Whale Tail 2024 Annual Open Pit Geomechanical Inspection

February 3, 2025

RE: Meadowbank Complex - Amaruq Site - 2024 Annual Open Pit Geomechanical Inspection

Hazard / Risk Assessment

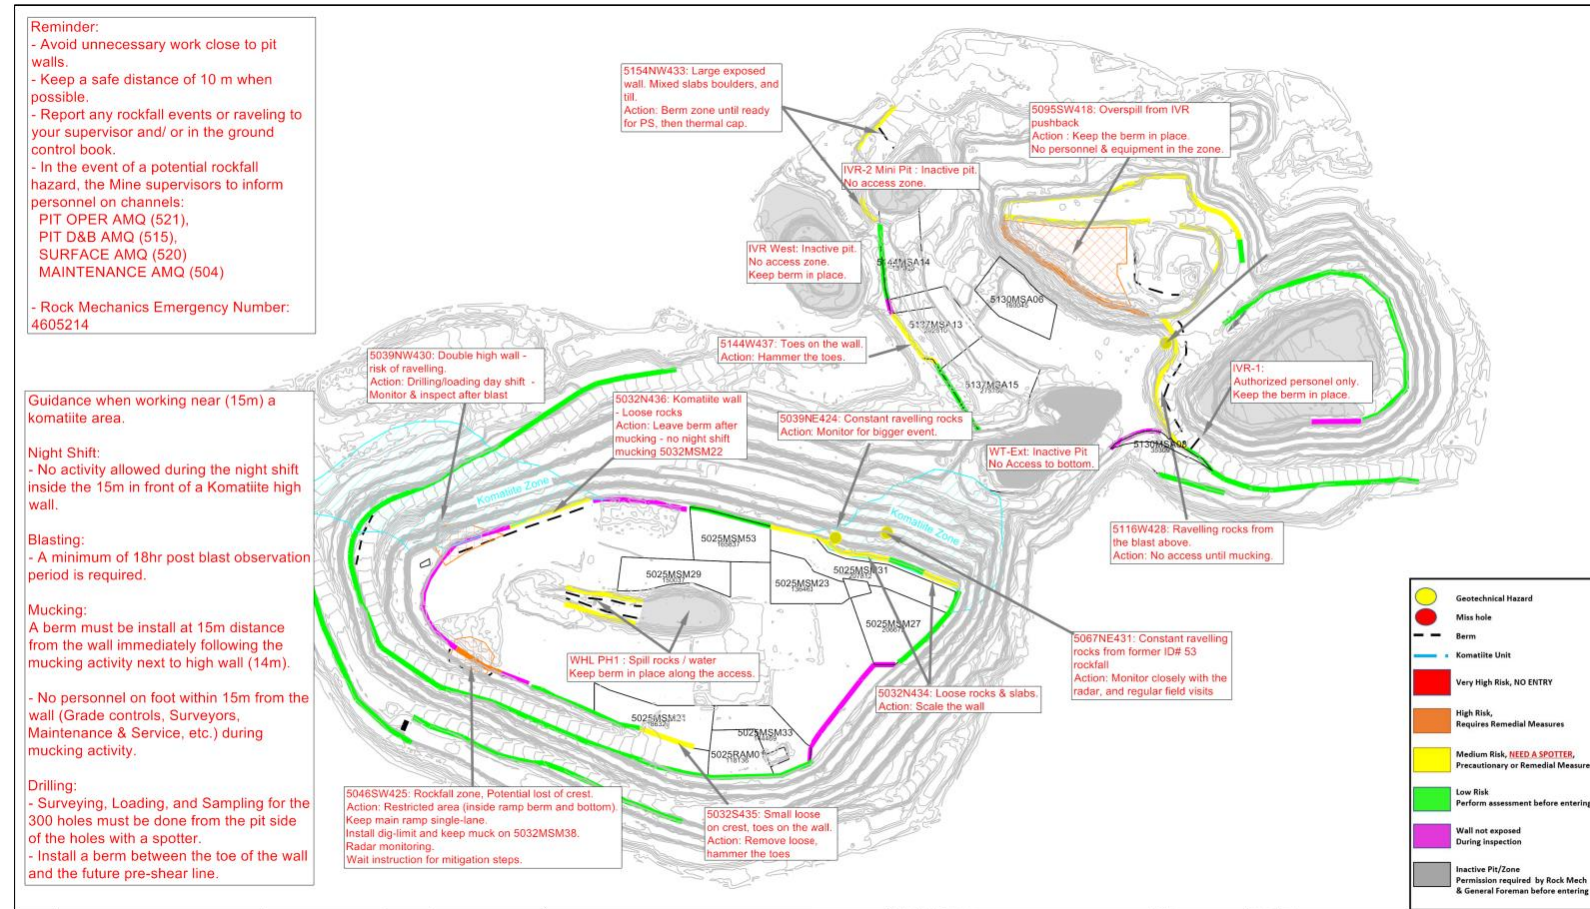
- Identified hazards and the required mitigation work are tracked on a Hazard Map available to the workforce that is updated every two weeks.
- Comments on the maps and their integration with work near the pit walls is provided on the next slide.
- There continues to be limited guidance on how to select the risk ratings. Recommend providing detailed guidance, including examples, on how to determine these ratings. The goal is to ensure that each member of the Rock Mechanics team can perform the assessment in a consistent and reliable manner.
- Note that these are hazard ratings and not risk ratings since only the likelihood of a failure is considered in the rating system.

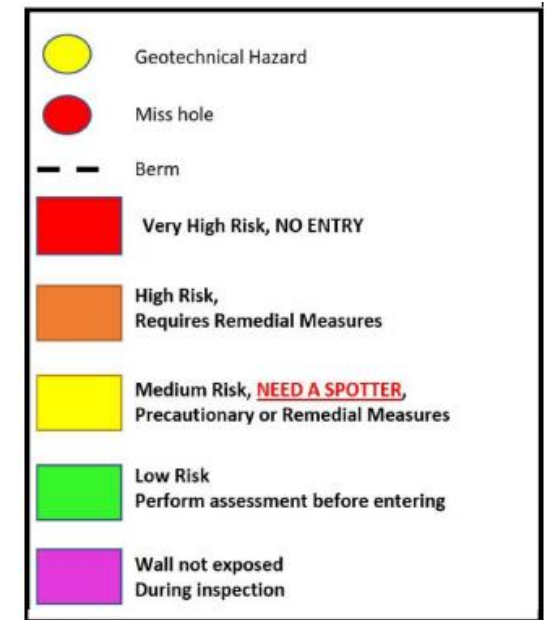
- There are multiple hazards documented in the Hazard Tracking Database that have been removed from the Hazard Maps as they are located in inactive areas or exclusion zones. These measures address the short-term risk but there is currently no mechanism to ensure these hazards are revisited or mitigated before mining resumes or prior to access for other activities (e.g., dewatering).

- Recommend having a layer on the map that remains internal to the Rock Mechanics team that tracks long-term hazards and areas that are a focus of monitoring (e.g., the wedge above the ramp on the West Wall of the Whale Tail pit) that do not necessarily need to be communicated to the larger workforce.

Bench Approval Process

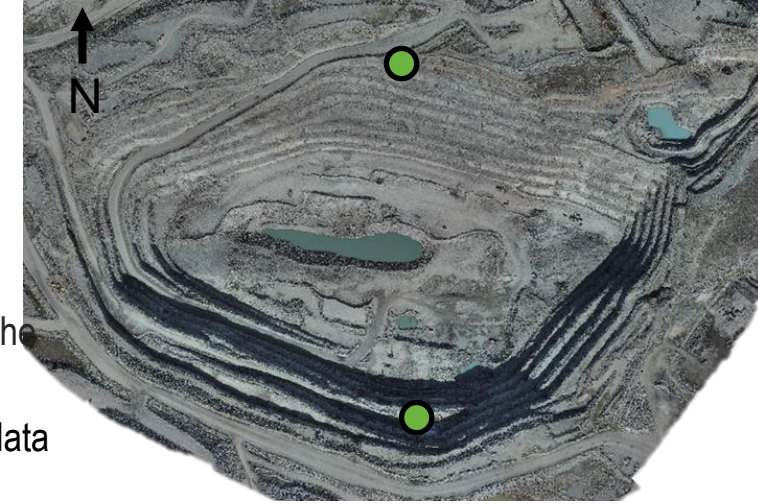
- Rock Mechanics completes a Pit Wall Approval for all benches on the final walls (both ultimate pit and interim stages). This process is a key control for managing potential rockfalls and bench-scale instabilities and is formalized within the Pit Wall Approval procedure.
- The condition of the bench and whether or not the face has been adequately scaled is assessed. The process is intended to be completed after each flitch is established and before work resumes in the area. A standard two-page report is issued each time.
- The mine has updated the Pit Wall Approval procedure so that drill patterns are only released to Survey and the drills once the required wall approvals are completed. This is endorsed.
- The use of a checklist to improve consistency between staff and avoid hazards being missed continues to be recommended.

Sub-Surface Monitoring

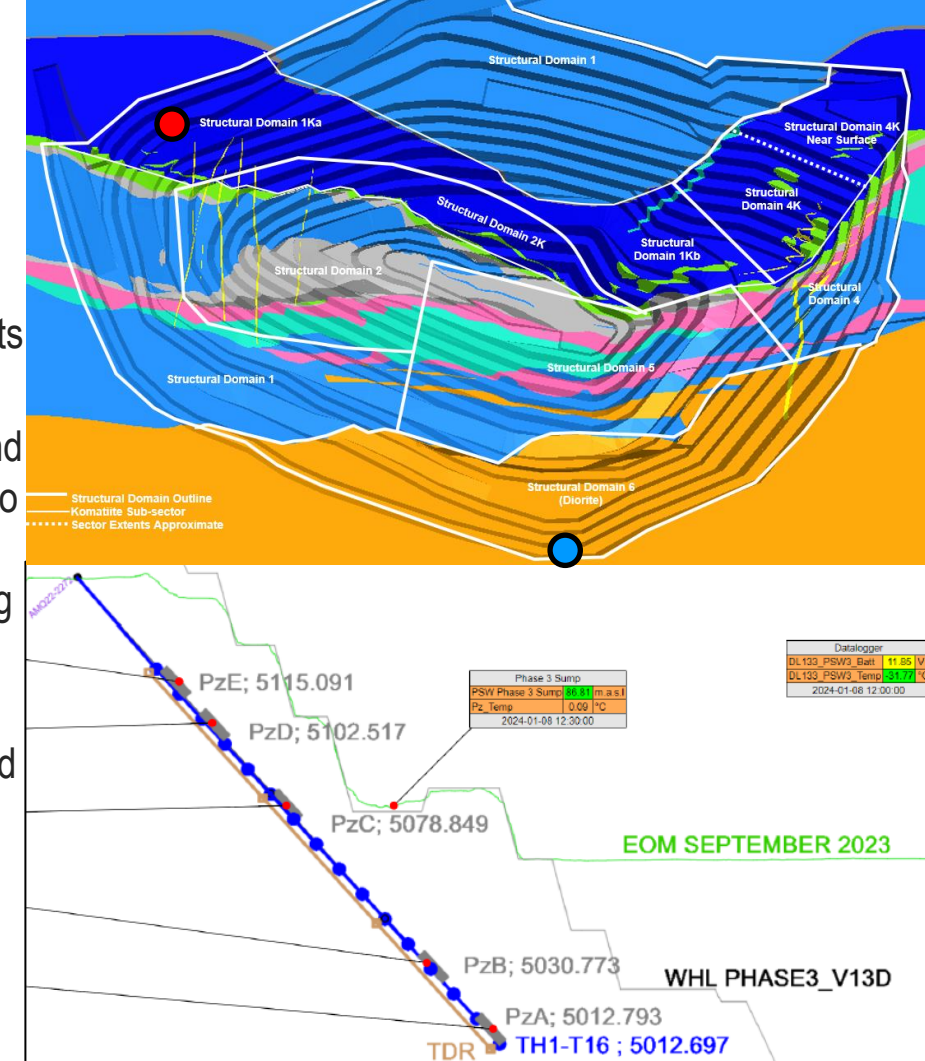
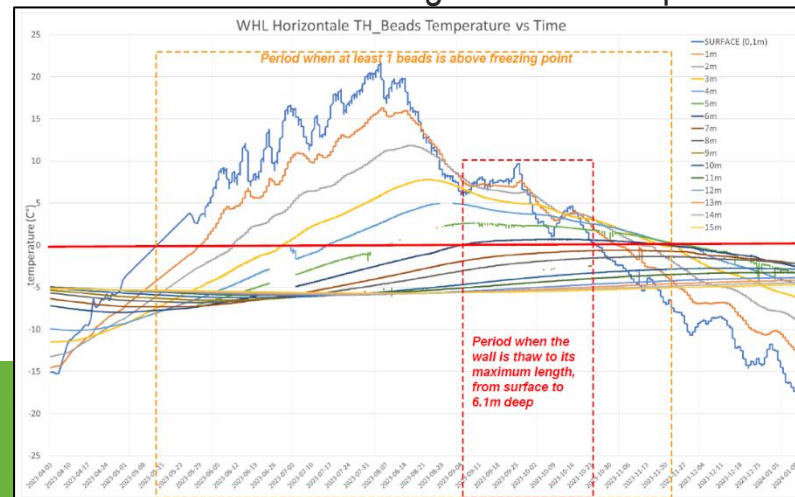
- A thermistor installed in the Northwest Wall (red dot at right) to a depth of 15 m behind the wall. The data indicate that the rock mass is fully frozen during winter but thaws to a depth of 6.5 m over approx. 4 months starting in May. Freeze back started in late October and took approx. 1 month. This information is useful for better understanding the timing and behaviour of rockfalls in the open pits.

- 5 VWP's and a thermistor string installed in a single drillhole in the South Wall (blue dot at right) in order to monitor the hydrogeological conditions within the talik exposed in the south wall. The mine has done a nice job summarizing and reviewing the data. The data show a clear response to mining and are consistent with a gradual drawdown of the piezometric surface as mining extends to depth.

Sub-Surface Monitoring (Cont'd)

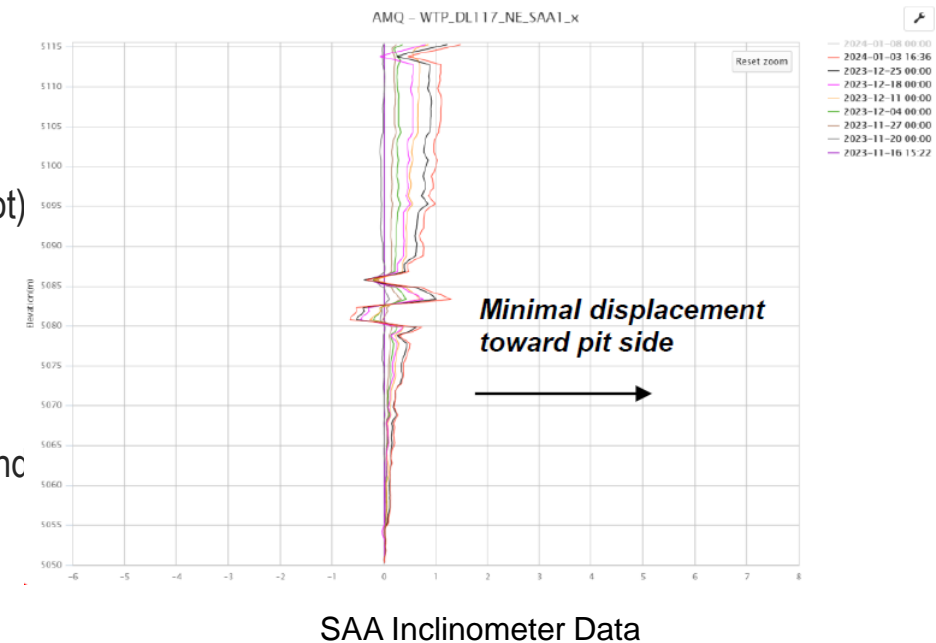
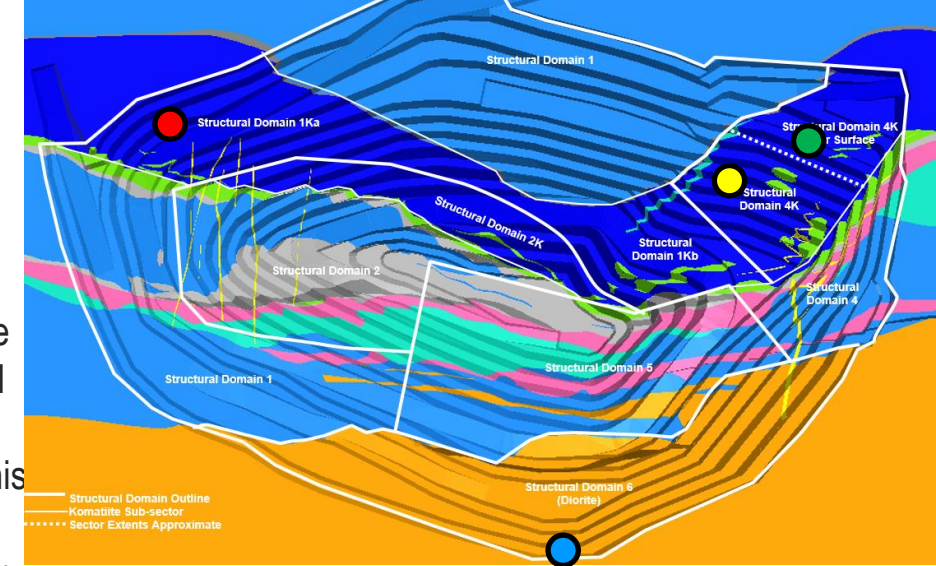
- A TDR was installed in the same hole as the VWP in the South Wall (blue dot at right). The data were reasonable and showed no evidence of deformation until April 4, 2023, when all data were lost below the first crimp at approx. 18 m. The cause for this is under investigation and blast damage is suspected. There is no evidence of slope instability in this area. The TDR is not currently being monitored.

- An SAA inclinometer and VWP were installed in the upper Northeast wall (green dot) in Q4 2023. This area was originally in a closed talik associated with Whale Tail lake but the instrumentation indicates that the rock mass is now frozen. The SAA has reported limited displacement (2 mm) towards the open pit (see graph at lower right). As a result of communication issues, these instruments are not currently monitored.

Data Collection & Design Verification – Bench Performance (2)

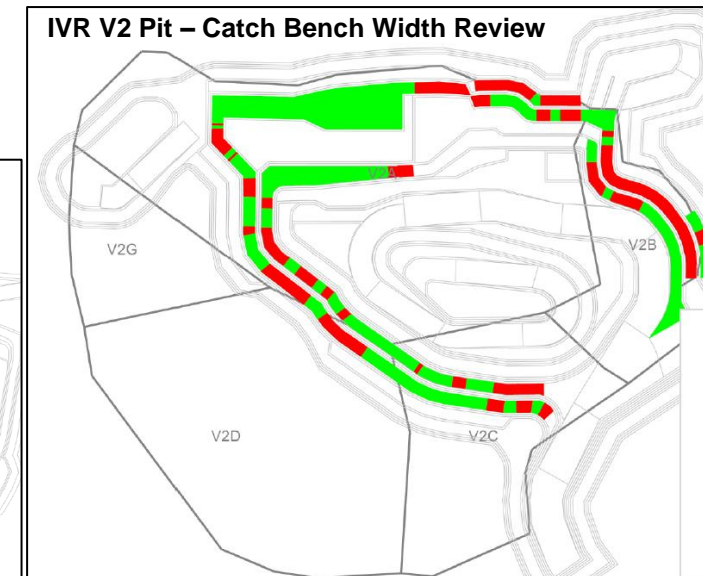
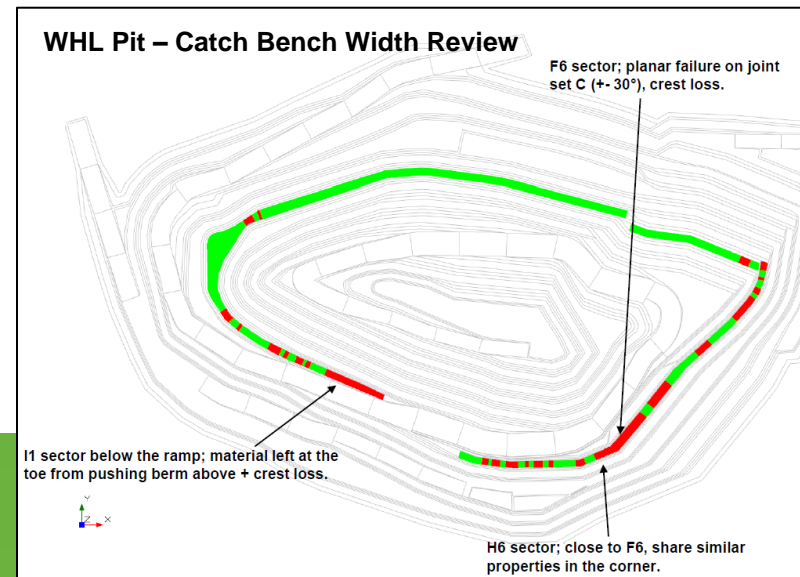
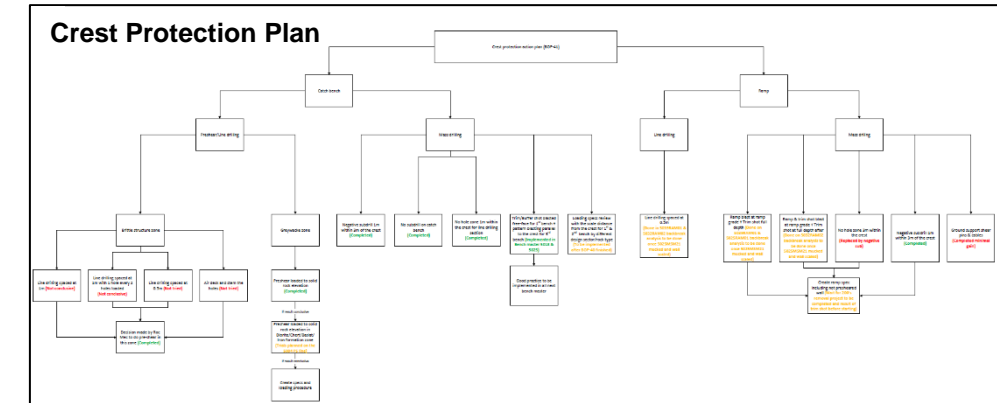
- In several design sectors, the effective catch bench width has often been less than design and, in some cases, the regulated 8 m minimum. This includes the IVR V2 open pit and Design Sector I1 in the WHL open pit.

- During the site visit, no immediate rockfall hazards were observed in these areas.
- Observations made during this and previous reviews suggest that the dominant cause is poor drilling and blasting practices, though adverse rock mass structure (e.g., WHL Sector F6) and scaling to remove identified hazards can also be factors.

- The mine implemented a Crest Protection Plan in 2024 and has progressively iterated through a series of trials to improve the catch bench performance. This includes line drilling, air-decking, negative sub-drill near the future crest position, etc. This is an important development and should be continued until the minimum catch bench width is reliably achieved.
